STATE OF MONTANA, NATURAL RESOURCE DAMAGE PROGRAM

MEMORANDUM

SUBJECT: Comments on BPSOU Grove Gulch Submittals Received from British Petroleum
– Atlantic Richfield (BP-AR) on 9/25/2023

Materials Management Plan, Figure 2 Waste Excavation Grading Plan

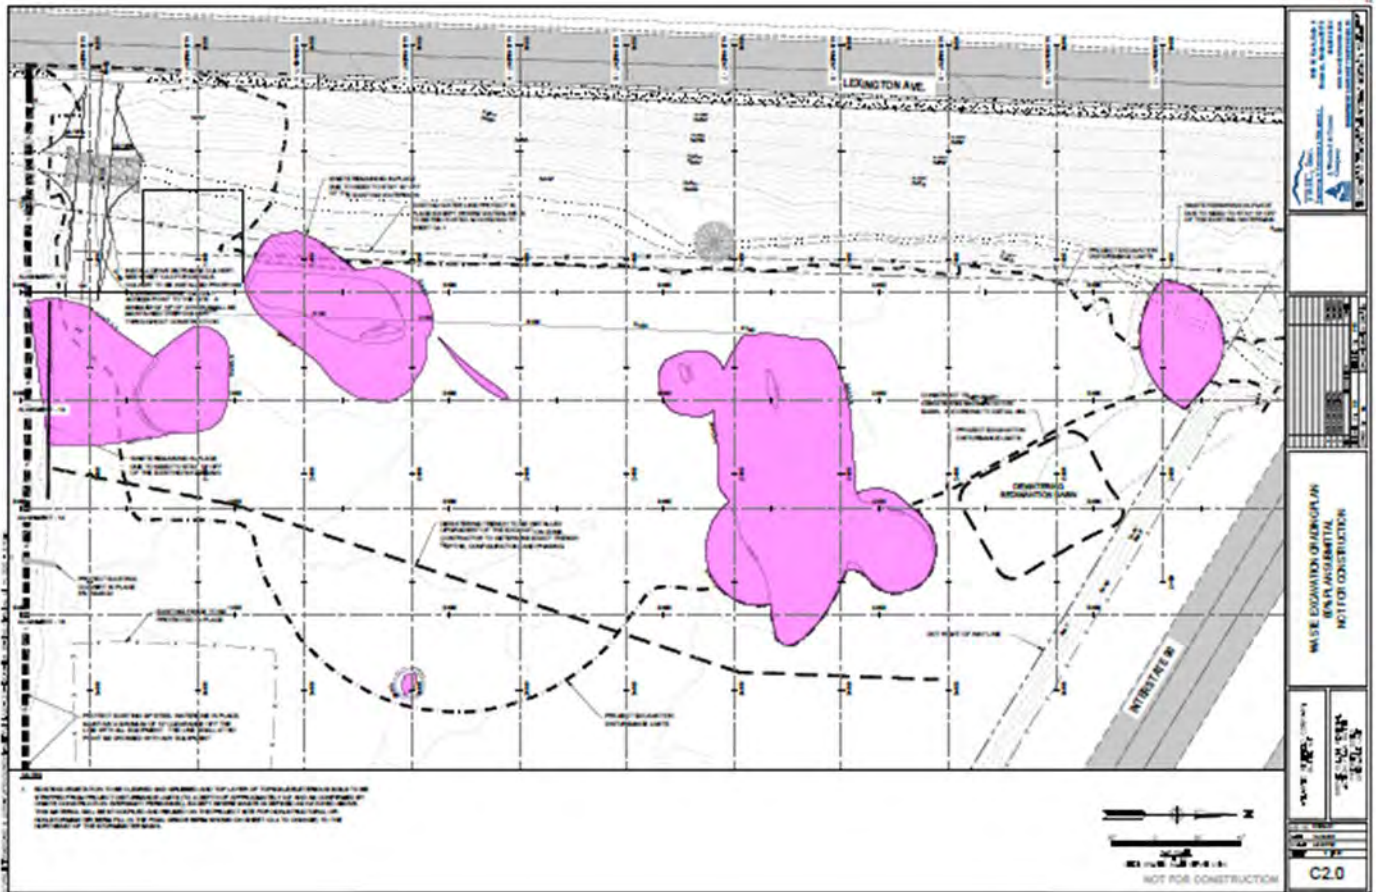
The site investigation, Grove Gulch PDIER and the resulting Figure 2 (Attachment A), is an incomplete and inaccurate approximation of the nature and extent of GG Wastes per Table 1 of the BPSOU CD. According to the Materials Management Plan, Section 1.3 – Project Description, page 8, “Figure 2 shows the extent of waste identified on site.” However, Figure 2 only shows small patches of “waste” within the bigger CD-required area for Grove Gulch. The forms on Figure 2 look like an artifact of sample distribution rather than the nature and extent of fluviably-transported and distributed Waste. General Comment 5 further describes how NRDP believes the EVS model is insufficient as the sole method of waste delineation. Complete delineation of Waste nature and extent requires additional field qualifying methods as well as confirmation sampling. Please identify where in the submittal is the document that describes how Waste will be characterized on the project area.

This decision tree does not explain how “material” will be “identified for excavation.” Is it implied that they will be visually identified? Will they be identified by utilizing Figure 2? Contaminants cannot be identified by visual or accurately predicted by modeling without statistically determined confidence intervals.
